Verdant Minerals Pty Ltd Ammaroo Phosphate Project - EIS Supplementary Report

August 2018

The EIS was circulated to agencies and available for public comment. A total of 150 written submissions (e.g. comments) on the EIS were received from NT Government advisory bodies and agencies, and two non-government organisations.

Figure 3-18 Model Revision Methodology (After MDBC, 2000)

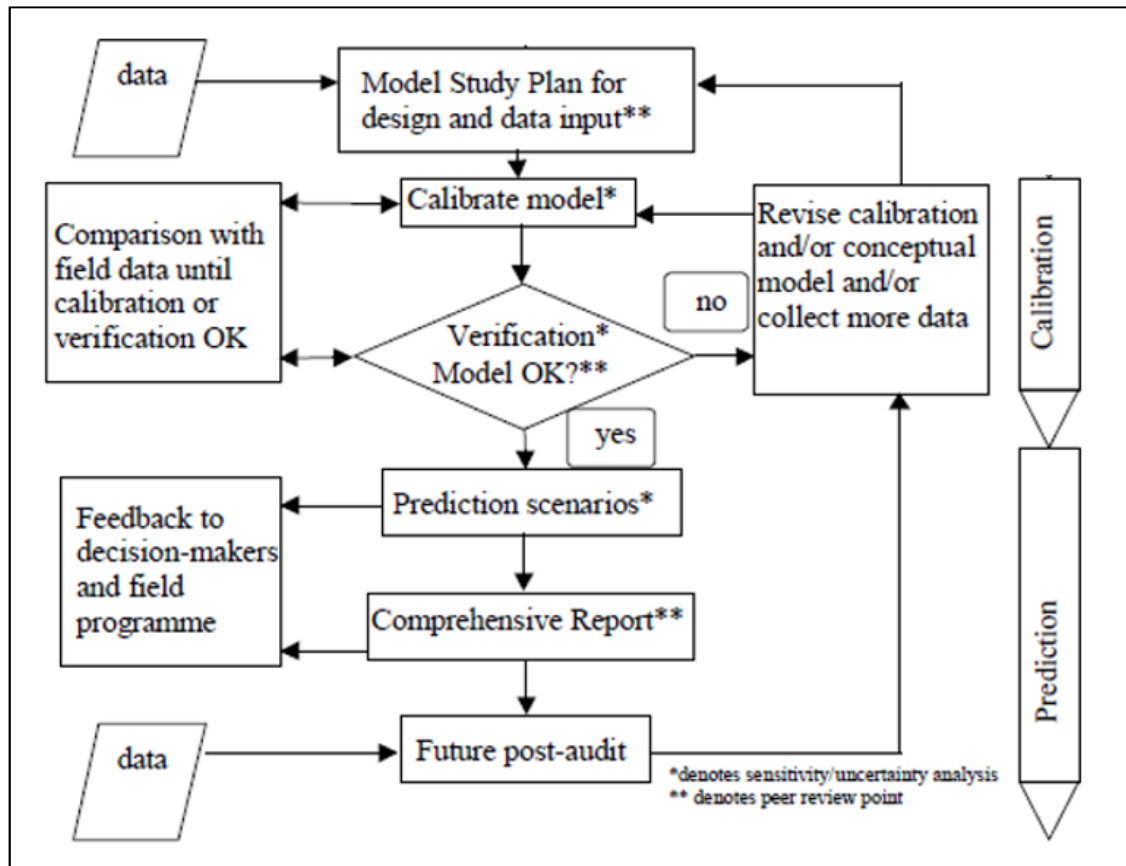
32	NT EPA	Model Calibration and refinement	Appendix H – Ammaroo Phosphate Groundwater Study 6.3	<i>Model revision and re-calibration will be undertaken annually if required.</i> (p.43) Provide an outline, including timing, of the process to be used to revise the model, re-calibrate and upgrade to a class 2 model. Confirm if future models will be assessed as part of ongoing authorisation under the MM Act.	Refer to Section 4.6.1 of the Water Management Plan.
33	NT EPA	Contingency	Appendix H – Ammaroo Phosphate Groundwater Study 6.4	<i>Additional water recycling methods will be explored</i> (p.44) The NT EPA expects the Project to be designed and operated for sustainable water use from the beginning, so this is unlikely to be a suitable mitigating measure following impact. <i>Alternative water sources will be explored e.g. extending / relocating borefield, but cost prohibitive</i> (p.44) The NT EPA notes that this is unlikely to be an appropriate mitigating measure if it is cost prohibitive. Include the mitigation measure of modifying pumping regimes if significant impacts associated with groundwater drawdown are identified.	<u>Water recycling</u> Noted. Refer to comment 17 for further information on sustainable and responsible water use. <u>Alternative water sources</u> Noted. Exploration for alternate water sources is cost prohibitive at this stage of the project's development, but once the project is fully financed and becomes operational; if necessary, alternate sources of water could be located within the near region. <u>Modifying pumping regimes</u> Modifying pumping regimes has been included as a mitigation measure in Section 4.6.1 of the Water Management Plan (refer Appendix 6).

Stage 1. Development of a Class 2 Groundwater flow model will be undertaken in accordance with the Australian Groundwater Modelling Guidelines (NWI, 2012). Volumes pumped from the bore field and Ampilwatja community water supply will be used to define hydraulic stress for the model. Water level drawdown measured at the monitoring bores will be used to provide a calibration data set. Aquifer parameters applied in the model will be adjusted such that the model drawdown matches the measured drawdown. The Approach is illustrated in Figure 3-18.
